**Subject: Route 105 (North Main Street) at I-495, Middleborough
Traffic Signals and Intersection Improvement Project
Project File No. 602603**

LivableStreets would like to take this opportunity to provide comments regarding the 25% Design for the Route 105 (North Main Street) at I-495 project in Middleborough as presented to the community on January 5, 2011.

Exhibit 4.38. Example of Bike Lane and Freeway Interchange

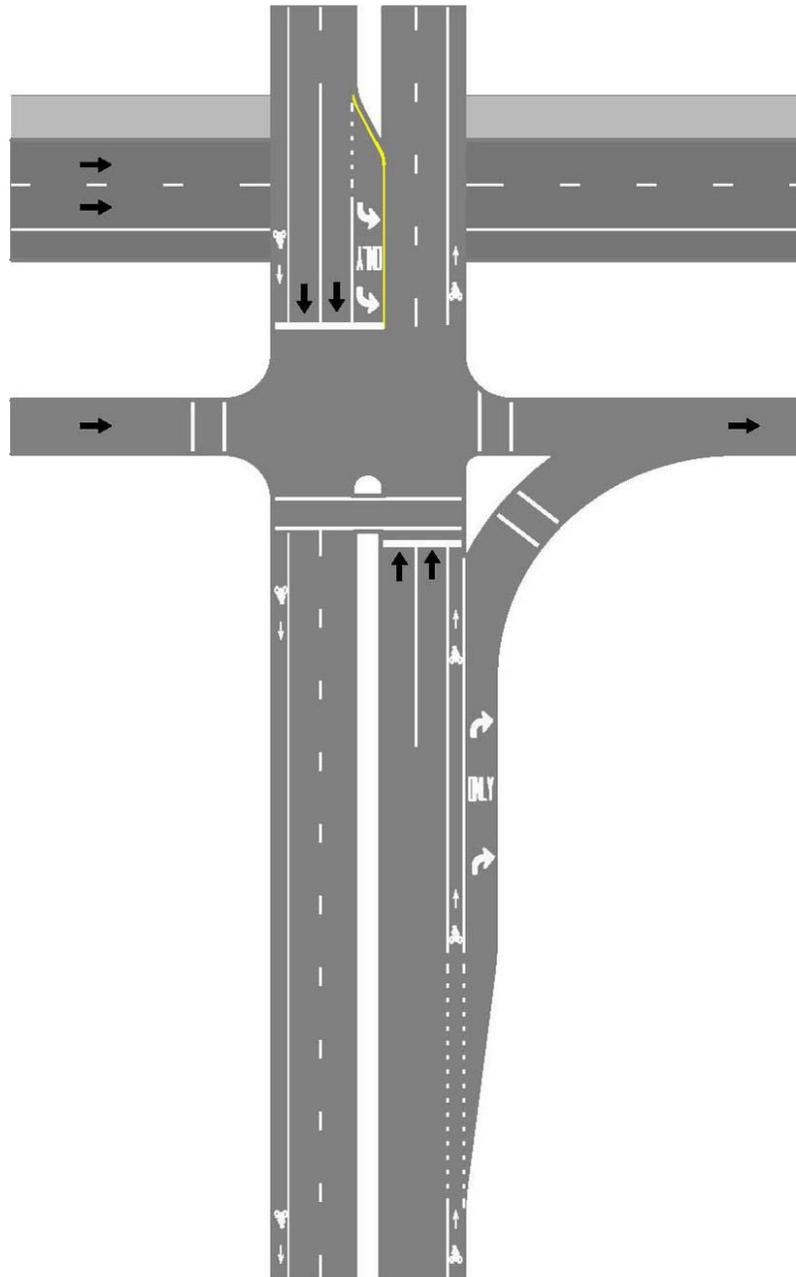
For example, the shoulder would be dashed across the on-ramps and off-ramps, and to the left of right-turn-only lanes (for example if there is one at the Rhode Island Rd intersection), to help guide bicyclists and alert motorists. The following diagram from the 2010 Draft AASHTO Bike Guide shows the general idea across a highway on-ramp. In this case, the bicycle symbols would be omitted.

It is not clear from the project description whether there will be dedicated turn/merge lanes prior the entrance (or exit) ramps, as shown in the diagram above. In the case where there are not dedicated turn lanes, we ask that the shoulder be dash striped across the ramp entrances/exits, similarly to the striping at the beginning of the right turn lane to the entrance ramp in the diagram above.
